ADMINISTRATIVE AMENDMENT (PD) ADD2023-00031

ADMINISTRATIVE AMENDMENT
LEE COUNTY, FLORIDA

WHEREAS, The Shoppes at Verdana Village, LLC filed an application for an administrative amendment to a Residential Planned Development on a project known as The Shoppes at Verdana Village to:

1. Subdivide the neighborhood commercial tract into four (4) separate lots; and
2. Remove site design details from proposed Outparcels 1, 2, and 3; and
3. Update the Commercial Lot Detail on sheet 3 of the MCP (Property Details and Property Development Regulations) to clarify the required front setback for proposed Outparcels 2 and 3; and
4. Add three additional deviations related to internal access and internal buffering; and
5. Remove page 3 of MCP approved by Resolution Z-20-006 since CPA2019-00008 was approved; and
6. Provide an open space table for the Neighborhood Commercial Tract;

NOTE 1: LOTS 2 & 3 25' FRONT SETBACK FROM WEST PROPERTY LINE

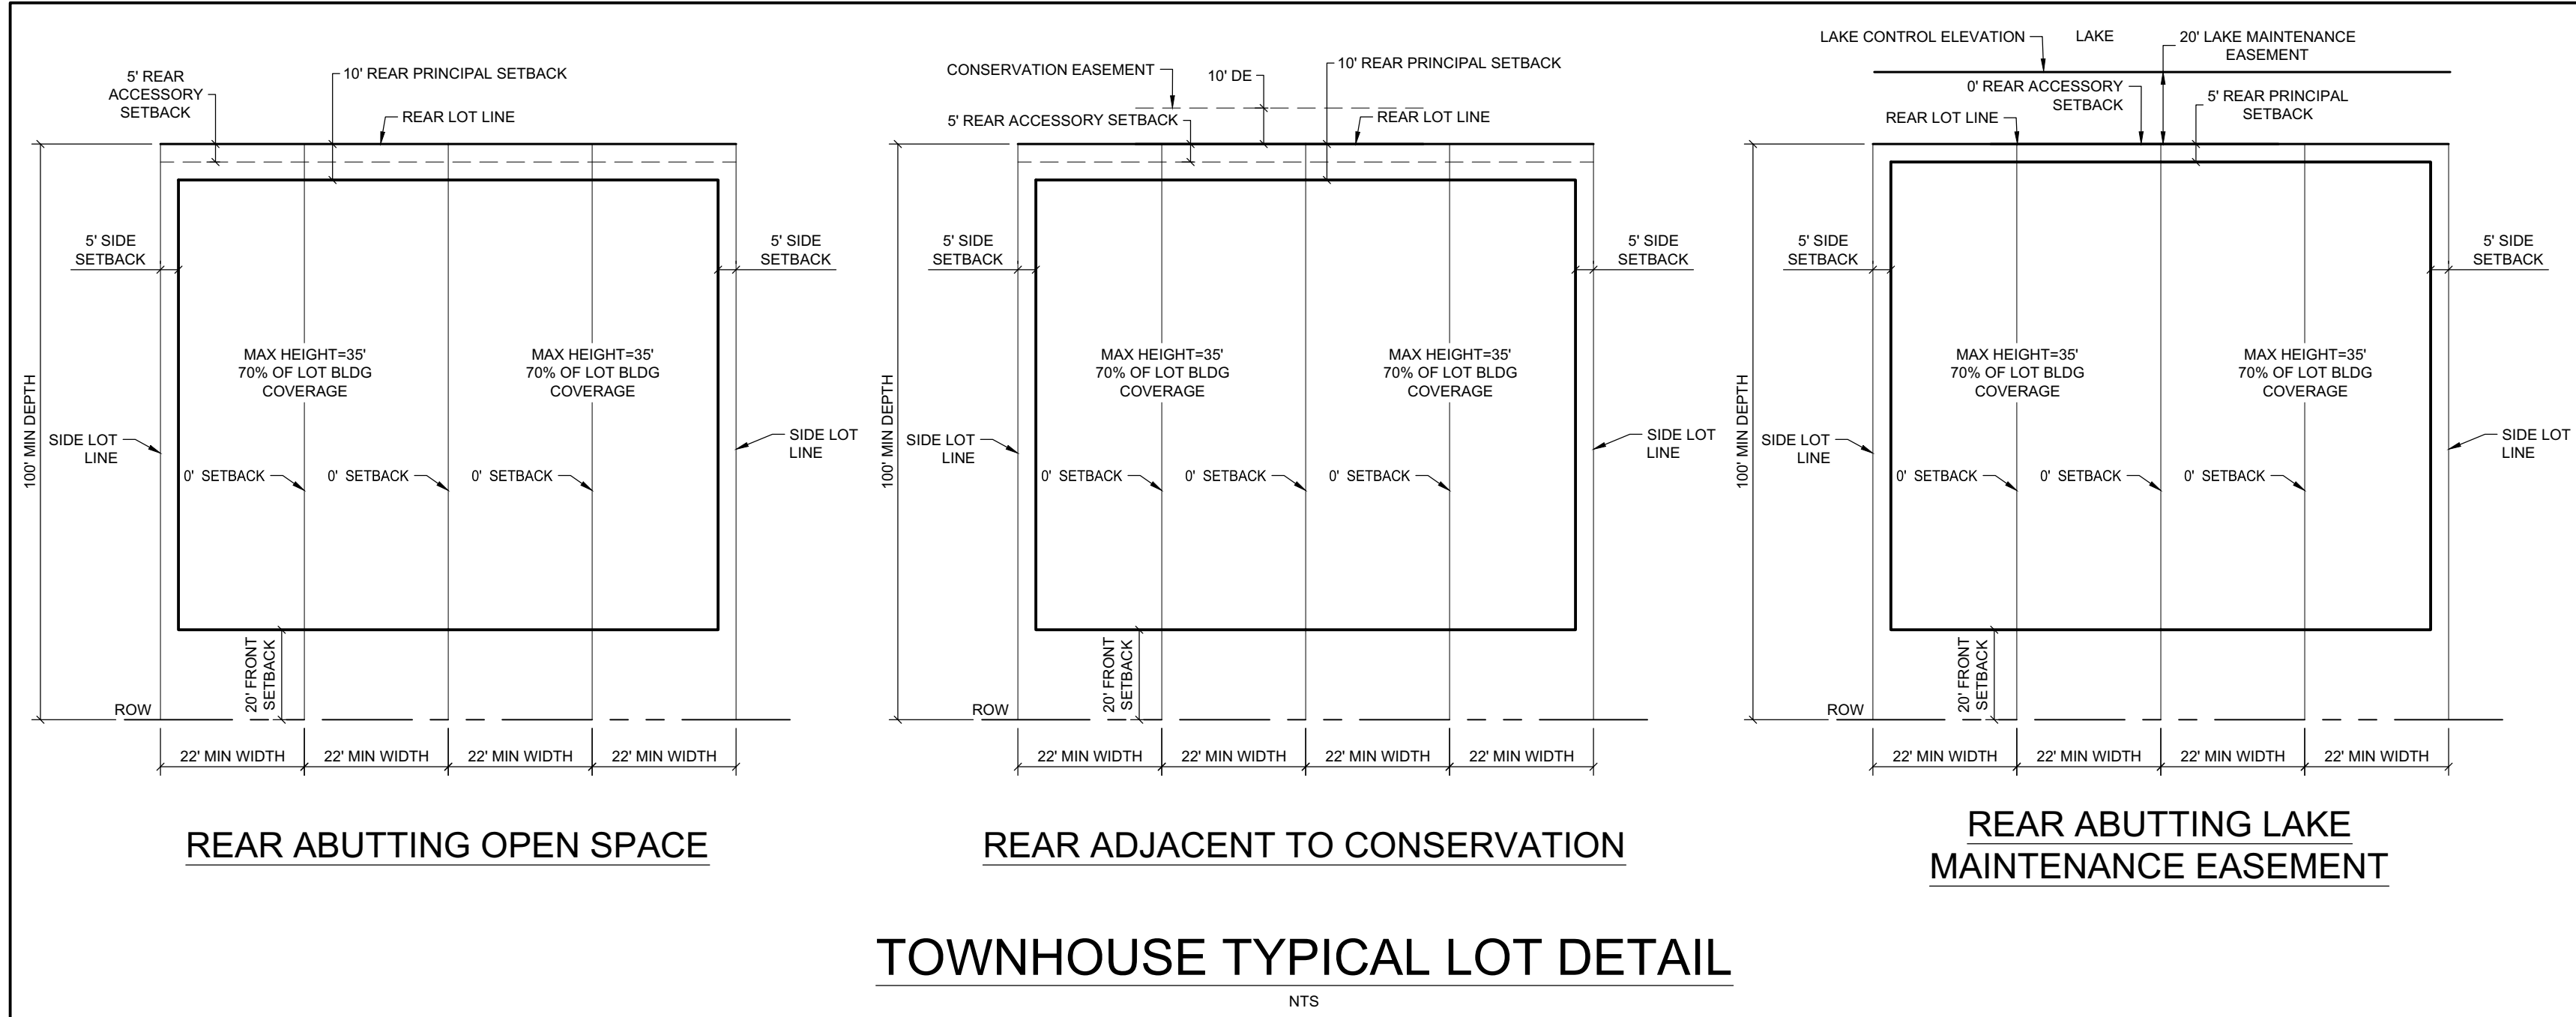
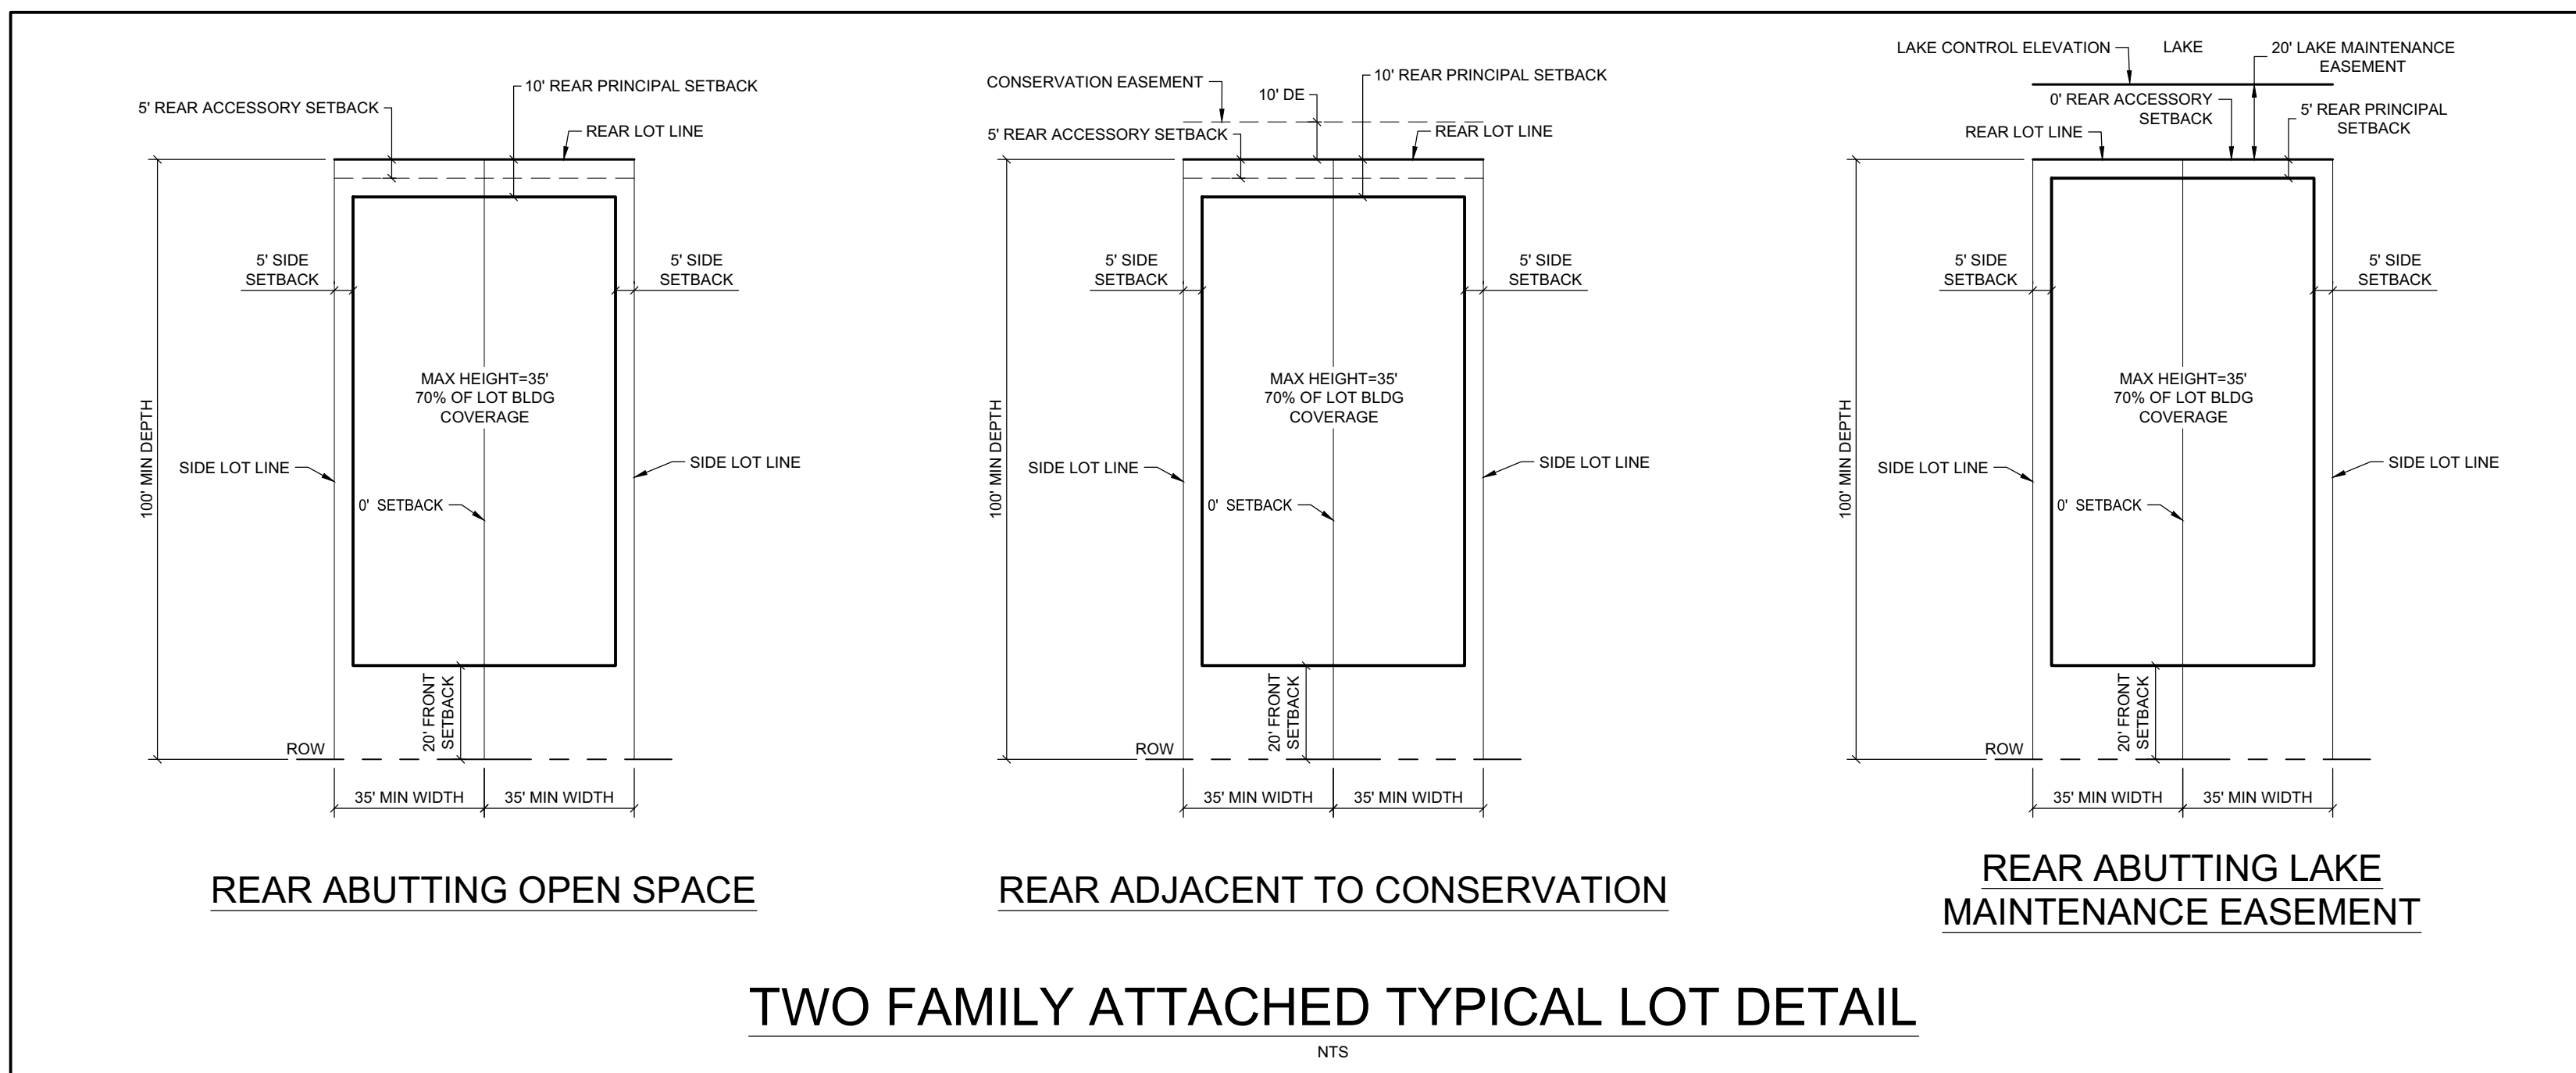
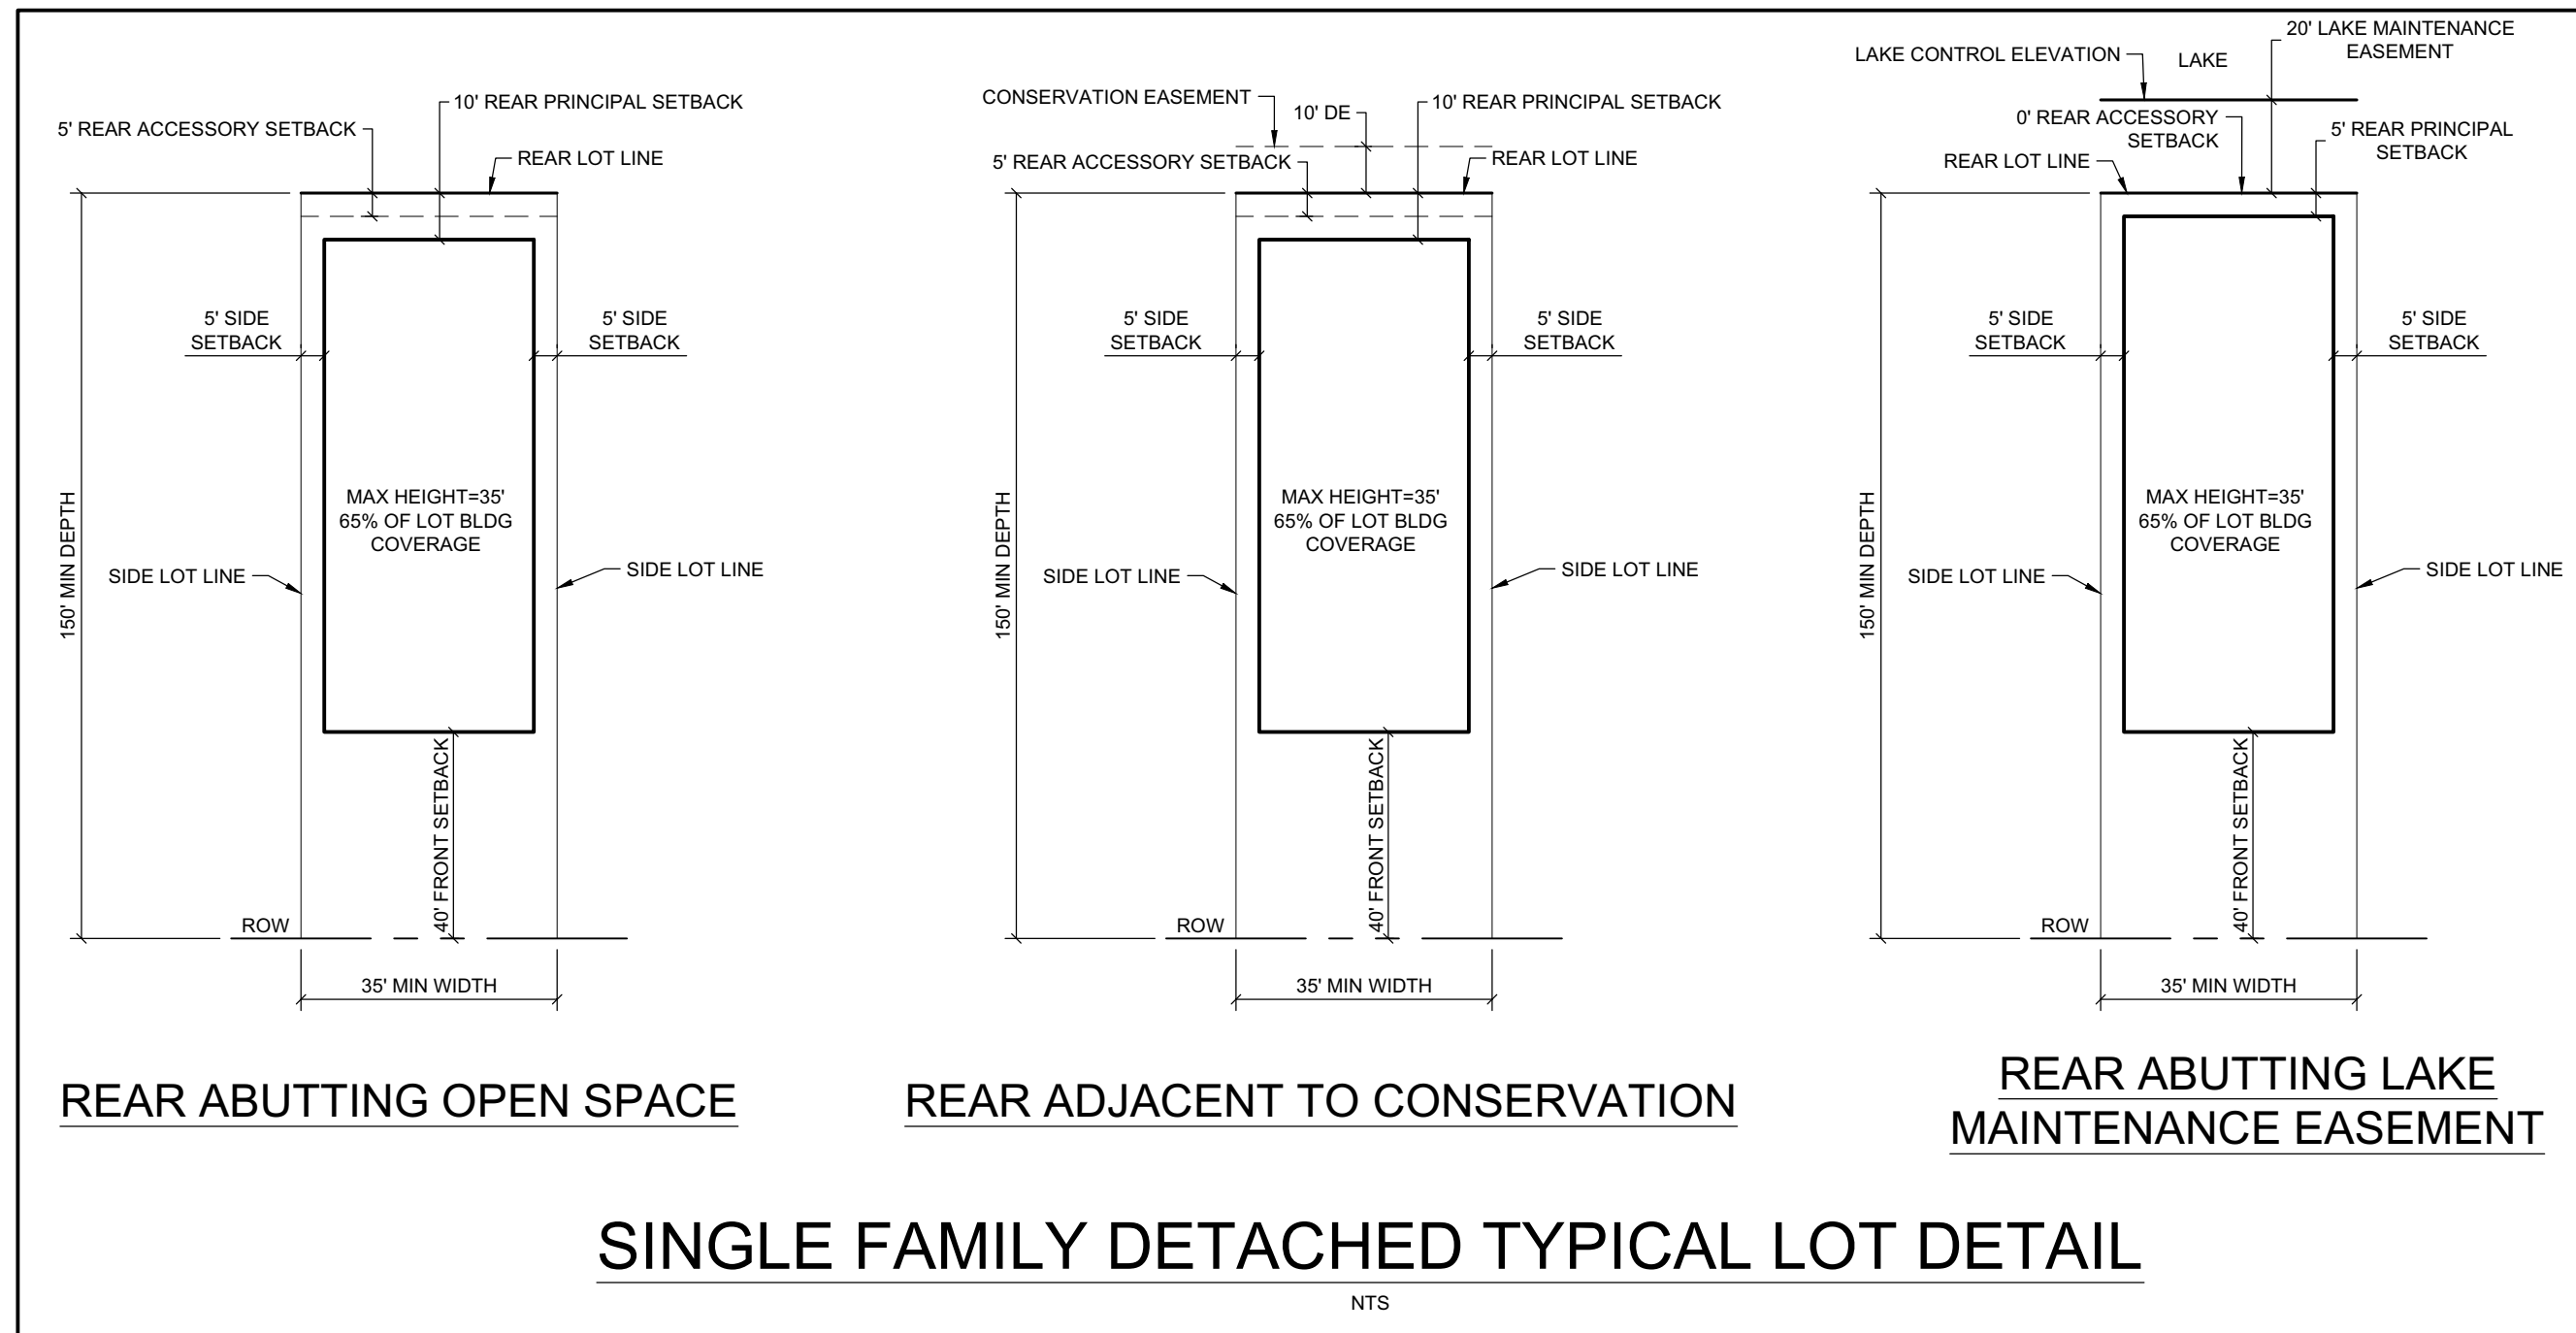
WHEREAS, the applicant has revised the Neighborhood Commercial Tract from one tract to four separate lots and removed the site design details from Outparcels 1, 2, and 3; and

WHEREAS, the applicant has revised the Property Development Regulations to clarify that the front setback for Outparcels 2 and 3 must be 25 feet from the west property line (Exhibit "D" and page 3 of Exhibit "C"); and

WHEREAS, the applicant is requesting this deviation to allow neighborhood commercial Outparcels 2 and 3 to abut and have access to an internal access easement and vehicular circulation without abutting a street designed and constructed to LDC Section 10-296 standards; and

WHEREAS, the applicant is seeking relief to allow no buffers between commercial uses and a three-foot-wide buffer between the commercial uses and the access easement; and

WHEREAS, Development Services staff have reviewed and approved the request subject to a condition requiring a development order to be in compliance with cross section G-G depicted on sheet 4 of the MCP (see Exhibit "C"); and

Prior to local development order approval, the site plans must depict the ingress/egress easement in substantial compliance with cross section G-G per sheet 4 of the Master Concept Plan.

Prior to local development order approval, the plans must depict a three-foot-wide buffer between the commercial uses and the ingress/egress easement. The landscape buffer must include seven-gallon container sized native shrubs specified at 48-inches-in-height and installed four-foot-on-center. The buffer vegetation may be installed in the Lee County Utility easement per Exhibit "F".
